ADDENDUM DESIGN STATEMENT

Change of Use to Upper Floors and Alterations
to create 46 Bedroom Hotel

1-3 York Street, Manchester

Fig 16: Linen room formed in the area of former communal office toilets. Legibility of the group of four windows to the side wall retained. *

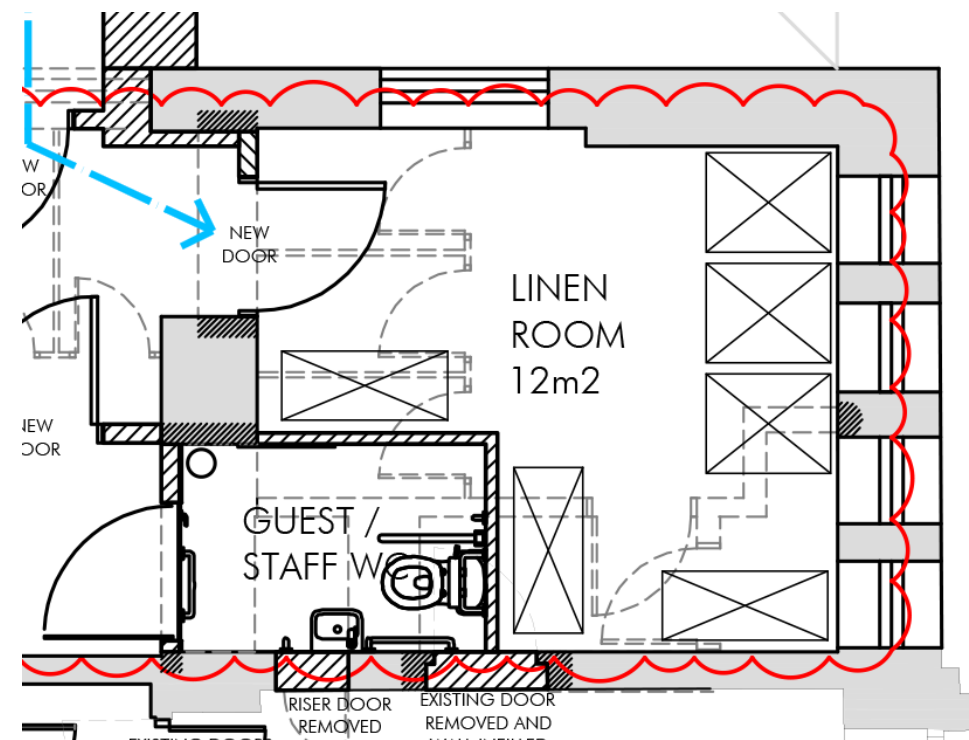
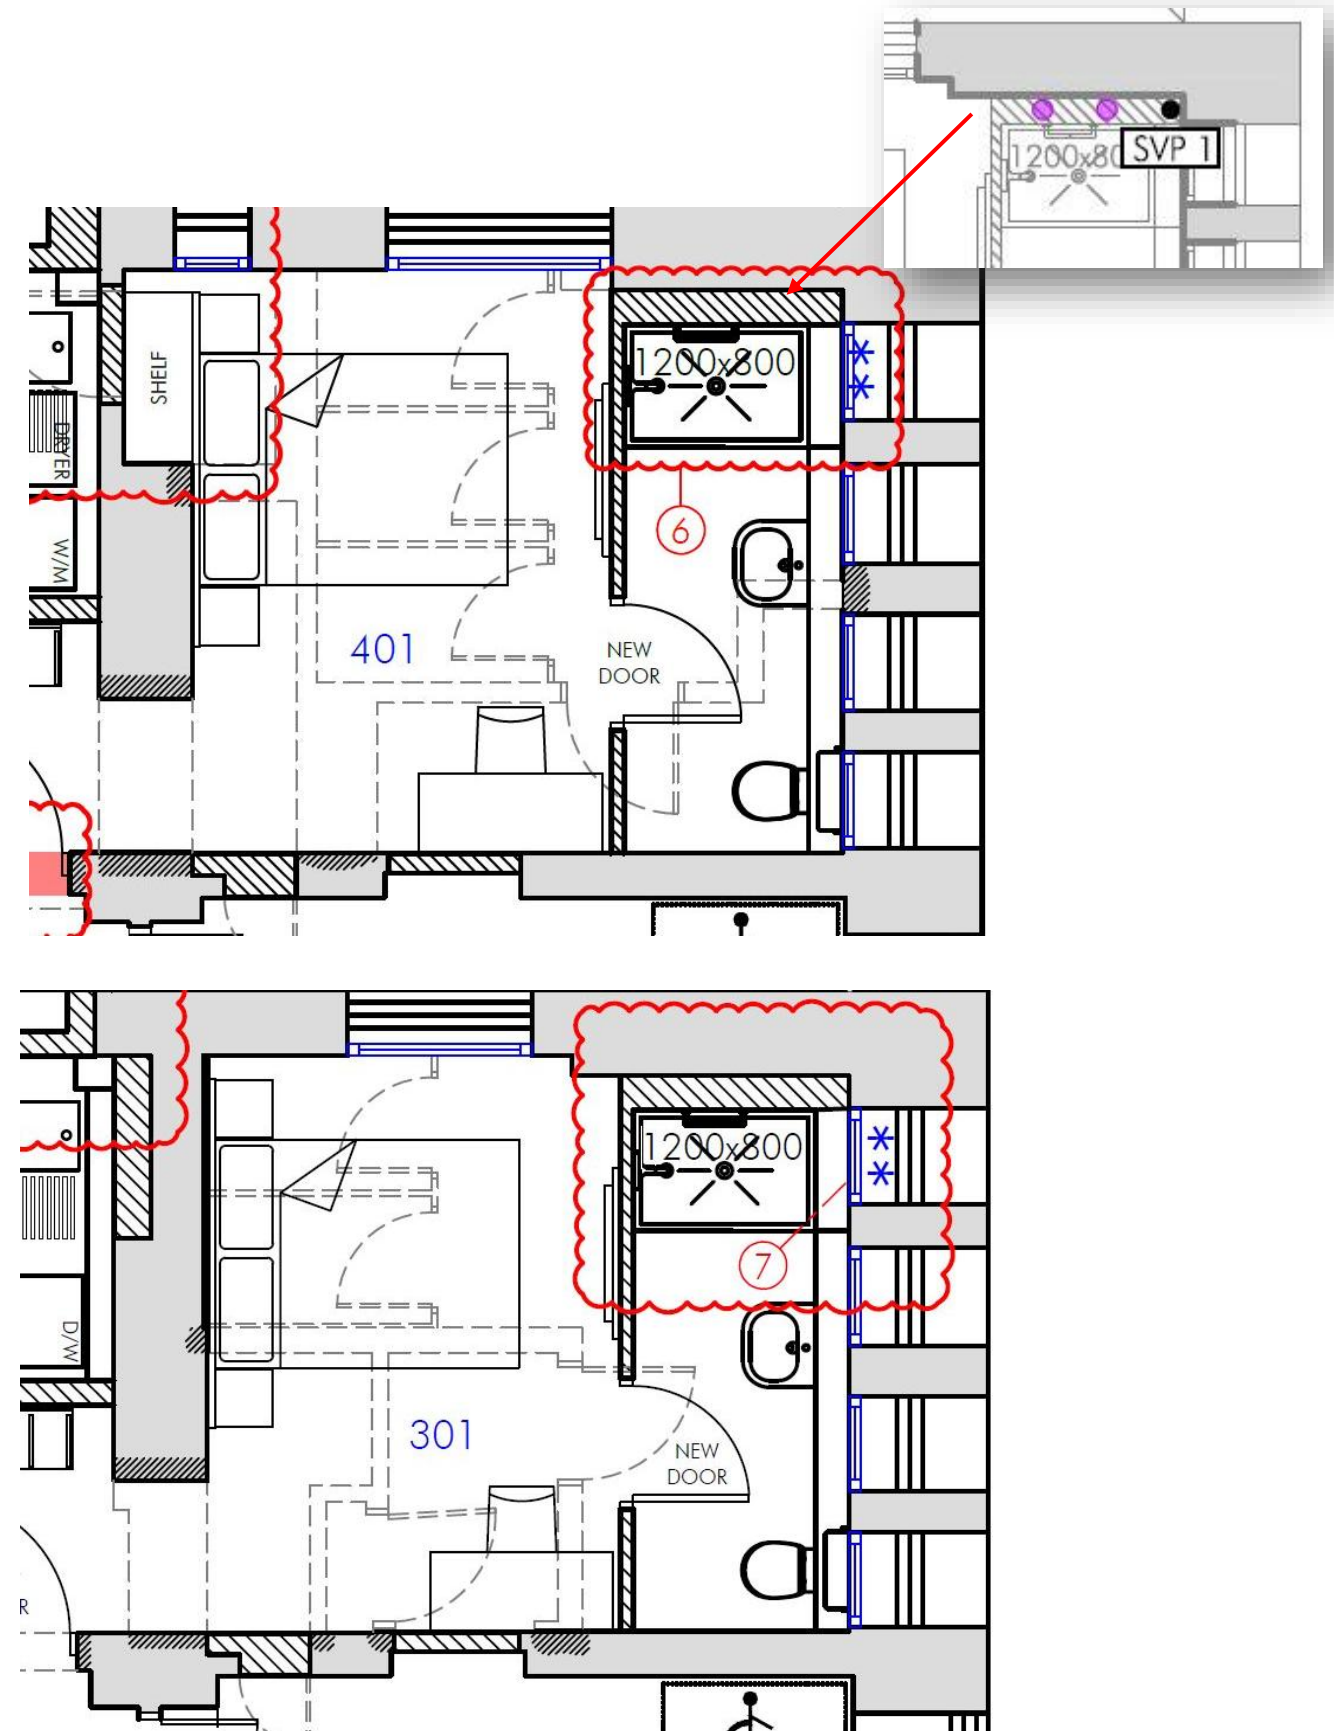
1.06	to the existing toilets (to reduce harm and preserve more of the historic floorplan & fabric) – ideally one toilet should be retained as communal toilets	Existing toilet fittings & partitions are not considered original fabric. Further discussion and mitigation is detailed in Addendum Design Statement section 1.5	1.5

3.09	Remove proposed 'dry-lining' to original walls in former toilets on third and fourth floor	This element of 'dry lining' (nib wall) has been omitted in favour of a glass infill to complete the shower enclosure. The lining to the rear of the shower is necessary to conceal supply pipework.	Drawing refs: AP03/H; AP04/H

The space that formed the original communal office toilets is proposed to linen room at second floor and bedrooms on all other floors. At each floor level this necessitates some form of alteration to the existing plan layout. In mitigation, the following measures have been incorporated:

- On the second floor, it was previously proposed that the wall be partially removed. We are now proposing that this wall be retained in full, with the existing doors removed and infilled to form a guest/staff WC and linen room.
- Where showers abut one of the existing window openings, these have been amended to reinstate the fourth window opening (which will have frosted secondary glazing applied) so that the group of four windows in that space remain legible.
- As requested, boxing around the shower has been reduced, the boxing to the rear of the shower must remain for vertical services to the shower – wastewater, H&C water and ventilation.

The conservation office has suggested that at least one of the existing toilet cubicles shall remain. These cubicles and surrounding wall tiling date from at least the 1980s refurbishment and are made of modern materials with a plywood backing to the wall tiling visible in places. Neither the wall finishes, partitions nor the sanitaryware found in these spaces are original and therefore do not warrant retention. The change of use to the building necessitates the re-purposing of these areas, therefore with the above mitigation in place, we believe sufficient work has been proposed to make legible the original character of the space.

Fig 18: Floor plan layouts of internal corner bedrooms at 2nd, 3rd & 4th Floors.

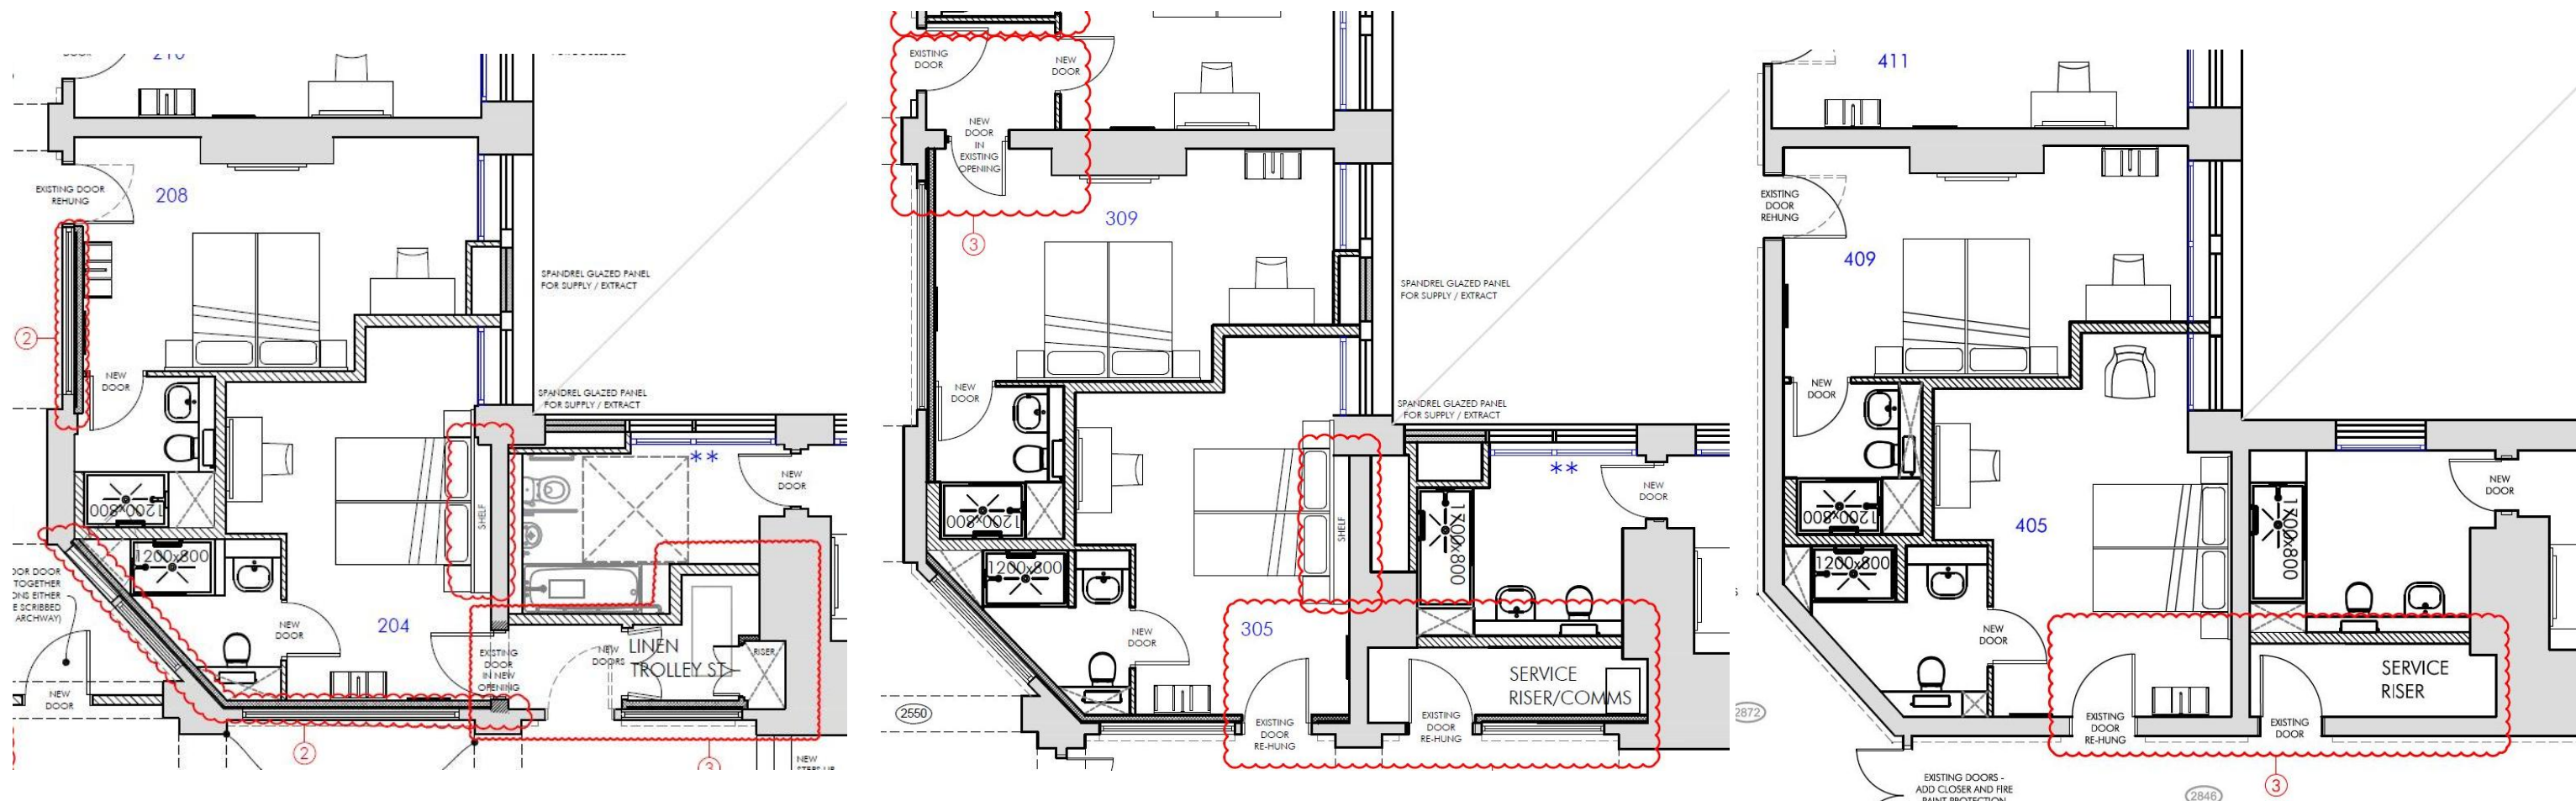
1.08	the subdivision to existing corner room on floors 2-4 (see below). The impact elsewhere needs to be better understood – to that end a sufficiently detailed HS is required.	This request would result in the loss of 3 bedrooms across the whole conversion with a direct impact on the project viability. Detailed discussion of this is given in the Addendum Design Statement section 1.6, including design mitigation. Refer also to revise Heritage Statement.	1.6

3.08	Remove proposed subdivision of bedrooms 204-208, 309-306 and 409-405	This request would result in the loss of 3 bedrooms across the whole conversion with a direct impact on the project viability. Detailed discussion of this is given in the Addendum Design Statement section 1.6, including design mitigation.	1.6

The Conservation Officer has expressed concern over the subdivision of a corner office space at second, third and fourth floors. Currently the scheme provides 46 hotel bedrooms. If this space were to form a large single bedroom, this would result in a reduction to 43 bedrooms. This would have a negative impact on the scheme viability and would directly affect the return on investment for the applicant. Further information on the economic viability can be found in the accompanying Planning Statement.

- The layout has been reconsidered to ensure that no new door openings into the spaces are required and they can function as two separate rooms without the need to form any new doorways in the existing fabric.
- The layout has been reconsidered to also ensure that any 'borrowed light' windows can be retained completely intact, and an internal lining added so they can remain restored and on view from the public hotel corridors.

Fig 10.2: the proposed lift location (purple) in relation to remaining section of ceiling glazing (part reflected ceiling plan)

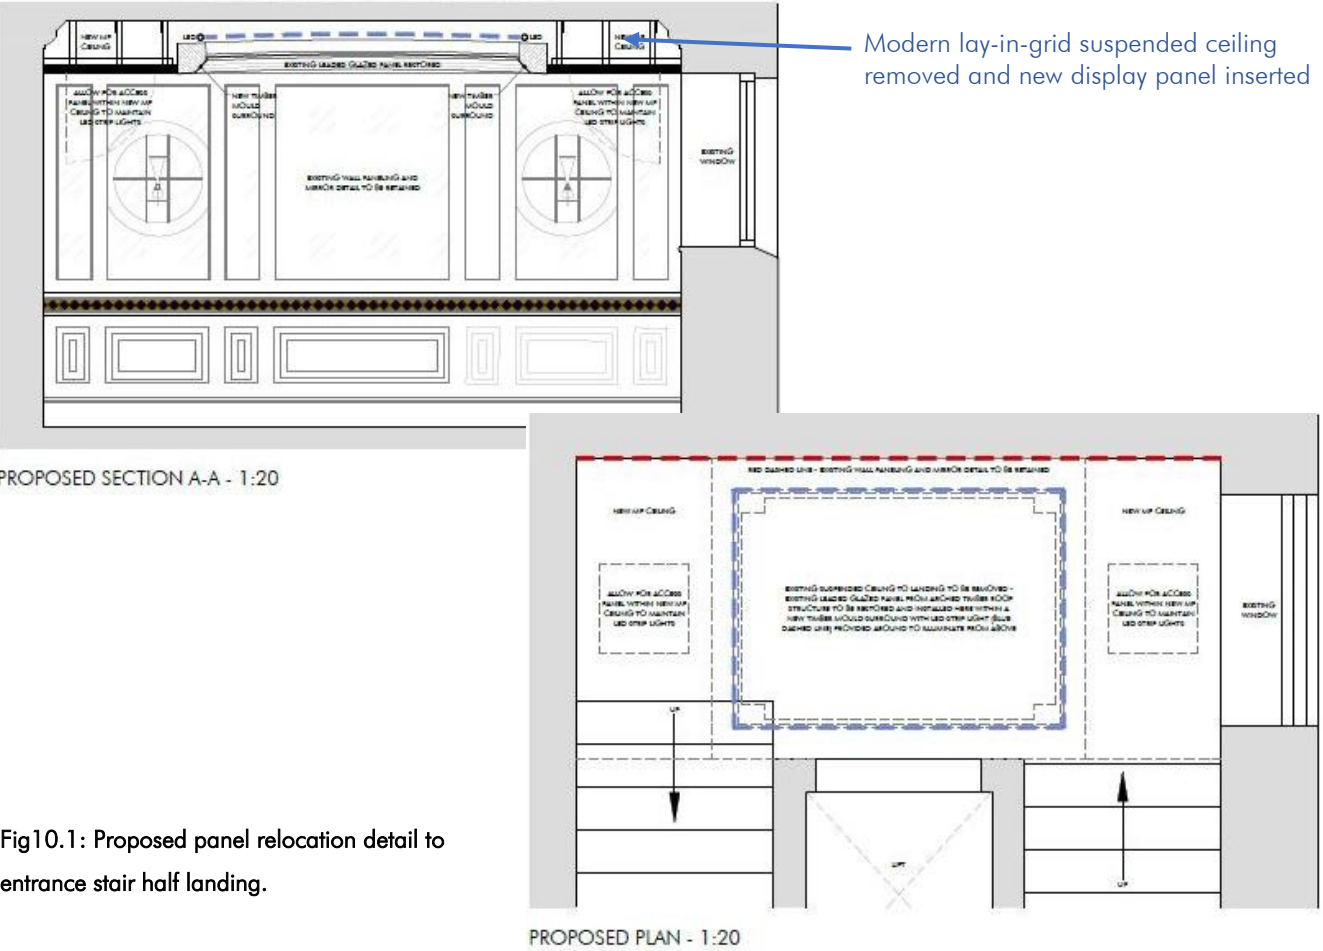
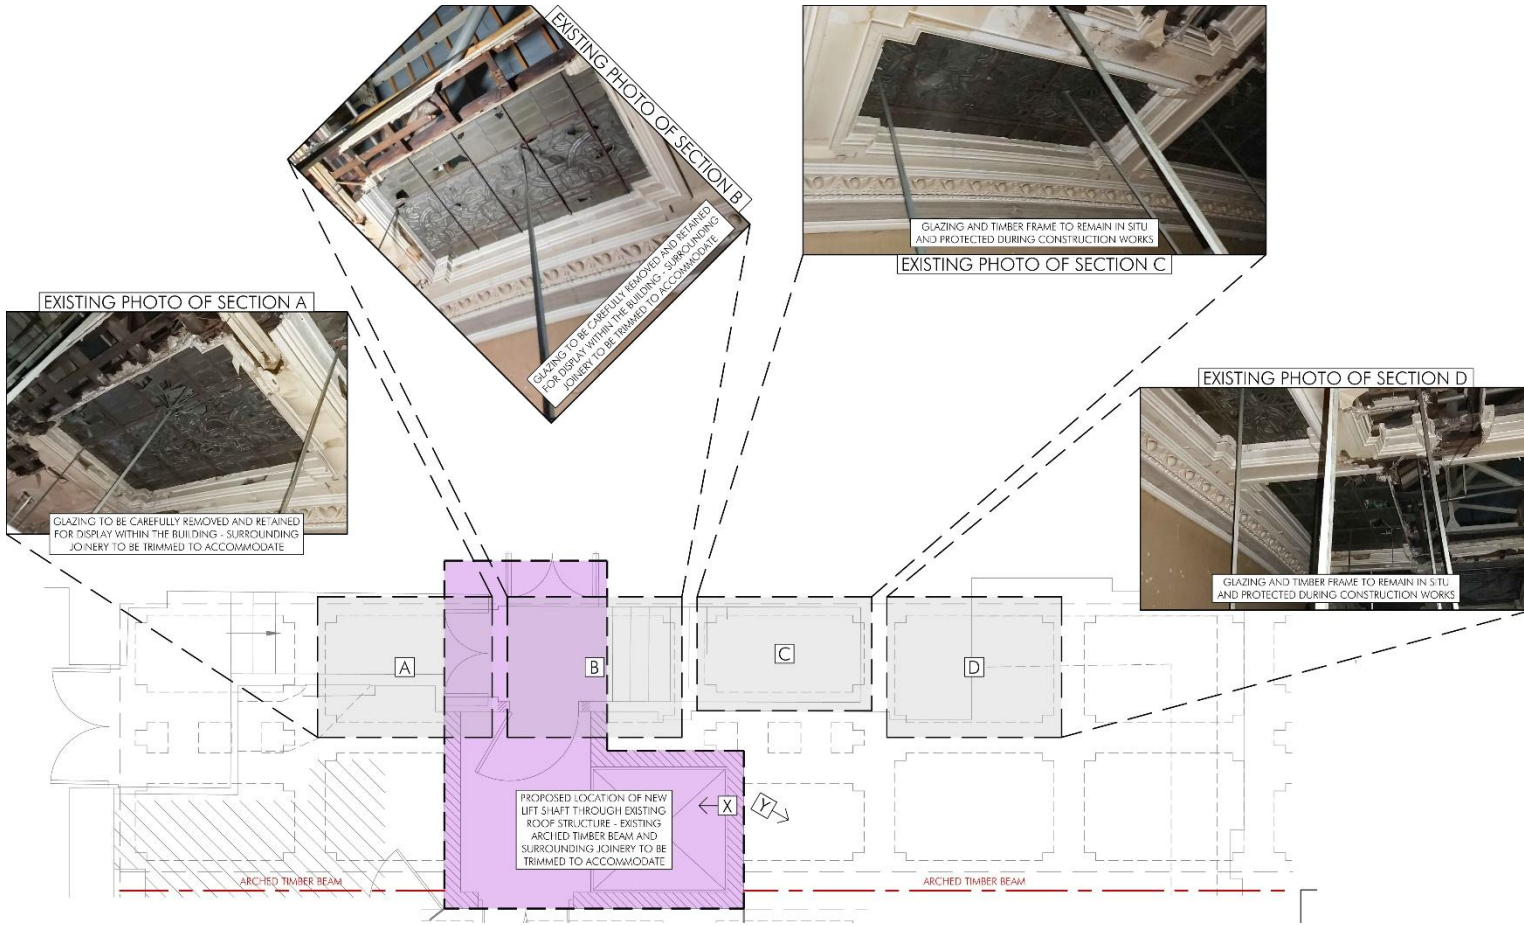
- The constraints and proposed mitigation for the 3 remaining internal glazed sections to be expanded in heritage report.
- The proposal to restore and display removed panel accepted as an appropriate means of mitigation.

More details on the restoration works and the proposed display of the removed panel would be required as part of the LBC. The restored section should be exposed.

When inserting the necessary service lift for hotel use, its location is governed by the existing roof structure – a combination of steel and timber roof construction. The necessary location of the new lift is shown in purple on the illustration opposite. This location conflicts with the remaining small areas of glazing. Therefore we propose to retain two of the panes insitu, to be protected during construction; and we propose to carefully remove the other two panels for specialist conservation repairs and cleaning. The two restored panels shall be displayed in the public areas of the hotel – for example in the main stairwell on a landing between ground floor and reception – along with some information/interpretation. The panels can be back-lit as a wall feature or mounted in the ceiling – the final detail for this installation can be agreed by Planning Condition if required.

In addition, we have submitted a drawing AP41 'Proposed Glazed Light Relocation Detail'. Although final details would be welcome as a planning condition, this detail has been prepared to demonstrate that the stairwell mid-half landing ceiling are of sufficient size to enable a reconstruction of a single glazed panel, clamped in a new timer frame and top-lit as a feature. This may be in conjunction with an information/interpretation panel to relate the feature to the history and origin of this almost entirely eradicated piece of the banking clerks' hall and its history.
